**SUBJECT:** Response to NRC Staff Follow-Up Questions 5 through 15 from  
November 9, 2001 Meeting Regarding a TMI Unit 1 Steam Generator  
Severed Tube

**THREE MILE ISLAND, UNIT 1 (TMI UNIT 1)  
OPERATING LICENSE NO. DPR-50  
NRC DOCKET NO. 50-289**

**Response to NRC Follow-Up Questions 5 Through 15 from  
November 9, 2001 Meeting Regarding the TMI Unit 1  
Steam Generator Severed Tube Root Cause**

Figure 1: Top-Span Fluid-Elastic Stability Margins of In-service, Plugged and Swollen Tubes

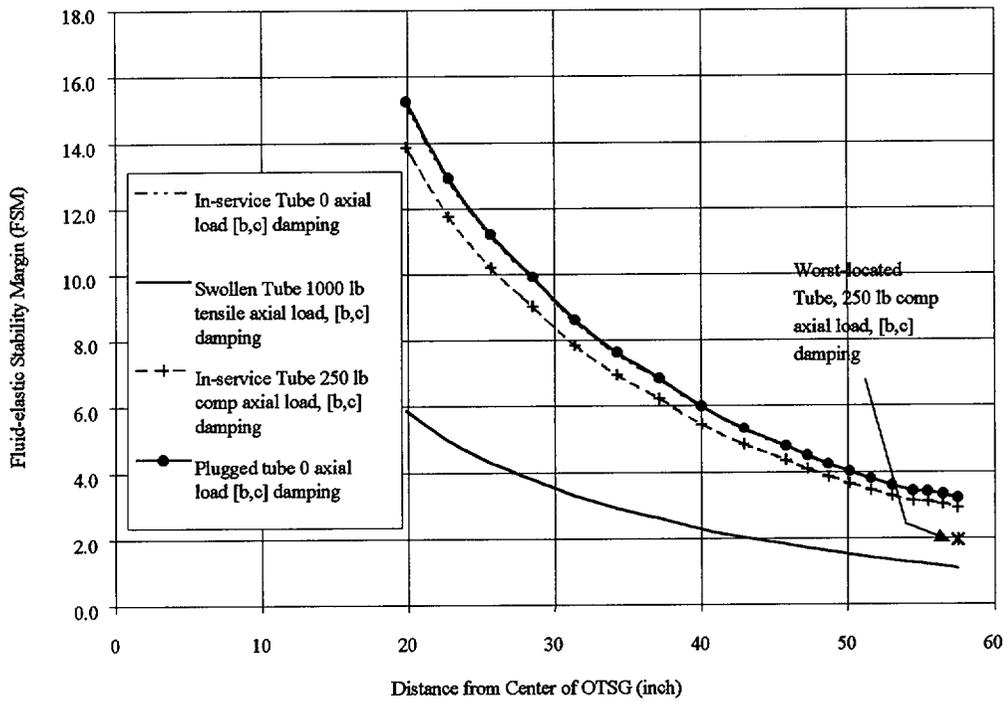
10. Describe nominal FIV response (e.g., stability ratios or some other figure of merit) under normal operating conditions at key locations in the bundle, including Regions 1, 2, and 3. Are these nominal FIV responses high enough to contribute to fatigue usage factors? What is the associated alternating stress and mean stress level?

As shown in Figure 1, under normal operating conditions, the fluid-elastic stability margins (FSM) – defined as the ratio of the critical velocity to the mode-shaped-weighted average span cross-flow pitch (or gap) velocity – are larger for tubes close to the center of the OTSG, and are dependent on the axial load of the tubes. However, the dependence is not very sensitive below the buckling load of the tube. The computed FSM between an axial load of 0 and 250 lb compression is not large as shown in Figure 1. For the same axial load, the stability margin generally increases for tubes closer to the center of the OTSG. As shown in Column 2, Rows 1 and 2 of Table 1, at the boundary away from the lane (Region 1), the stability margin of an in-service tube with zero axial load is 3.2. With an axial load of 250 lb compression, it is still equal to 2.9. The latter would decrease to 1.9 (Table 1, Column 2, Row 3) for the tubes located at the points of highest cross-flow (peripheral tubes on both sides of the lane, or Region 2 tubes). All the above results are based on a damping ratio of [b,c]. Based on both laboratory tests on tube samples and in-air tests of a full-scale OTSG, this is a representative and still conservative damping value for an in-service OTSG

Figure 3: Bottom-Span Fluid-Elastic Stability Margins of In-service, Plugged and Swollen Tubes

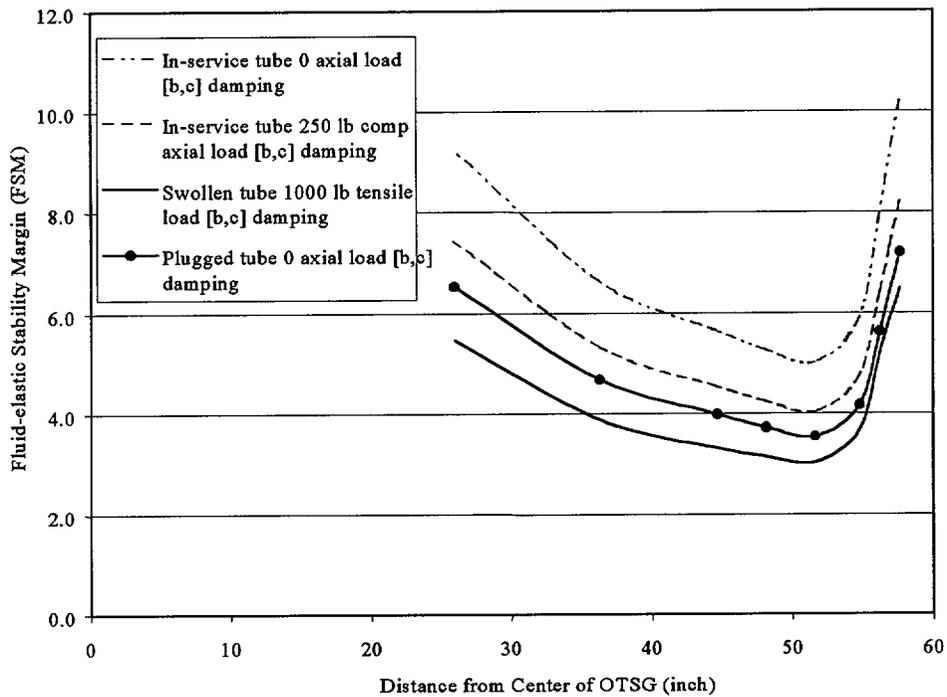
12. For plugged tubes, describe changes in FIV response in these regions for plugged tubes if tubes become swelled. Discuss all revisions to boundary conditions, applied loadings, and other model inputs and basis for these revisions.

Figure 3 shows the computed fluid-elastic stability margins (FSM) for the in-service tube with a damping ratio of [b,c]% ([b,c] basic plus 2% due to the two-phase mixture). Unlike the top span, the minimum FSM in the bottom span does not occur at the peripheral tubes. This is because as the feed water enters the tube bundle through the water ports, it is heated and changes into a two-phase water steam mixture with a much larger specific volume than sub-cooled water. The cross-flow pitch velocity increases as the mixture density decreases to satisfy the continuity equation. As the feed water enters further into the tube bundle, it starts its upward turn. In the OTSG bottom span, the maximum cross-flow velocity occurs, not at the periphery of the tube bundle, but at a point approximately 52 inches from the center of the OTSG. This is where the minimum FSM occurs. Tube B66-130 is not located at or near the point of minimum bottom-span FSM, it is almost 57 inches from the center of the OTSG.

As shown in Figure 3 and also Table 2 (Column 2, Rows 1 and 2), the minimum bottom span FSM for a normal in-service tube is 4.0. The minimum bottom span FSM of a swollen tube at the same location is 3.0. The minimum bottom span FSM of tube B66-130 is between 5.4 to 6.5. Thus, the worst-located swollen tube would have a stability margin in the bottom span higher than that of the top-span active mode of the worst-located in-service tube (Region 2).

Fluid-elastic stability margins of bottom-span active modes of plugged tubes are plotted in Figure 3 as a function of distance from the center of the OTSG and are also given in Table 2. Plugged tubes generally have smaller margins against fluid-elastic instability compared with those of in-service tubes; but have higher margins compared with those of plugged and swollen tubes. This is because the assumption that plugged tubes are filled with secondary side fluid bias the non-structural mass of the tube towards the bottom span, resulting in a larger participation from the bottom-span active modes compared with that of a in-service tube. As in in-service tubes, the smallest margin
